Access Compliance Report

Public Rights-of-Way

(Pedestrian Signals)

Intersection ID: N/A	Main Street:	Cross Street: N/A	Location: N/A
ADA ID: 00EA58C11C8C	Signal Type: One Push Button-Non APS	Overall Compliance: No	Severity Score: BTN 1: N/A BTN 2: N/A No BTN: N/A
Codes/Mitigation Info/Possible Solution		Field Measurements/Component Compliance

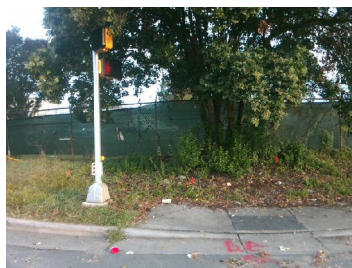
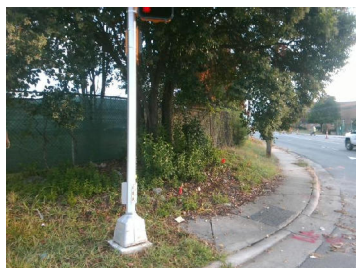
PROW/ADA: R209.1, TMUTCD 4e.08, R404.3, R404.1, R406.2, R404.7.3

Possible Solutions: Provide PAR As Indicated. Provide Clear Space.
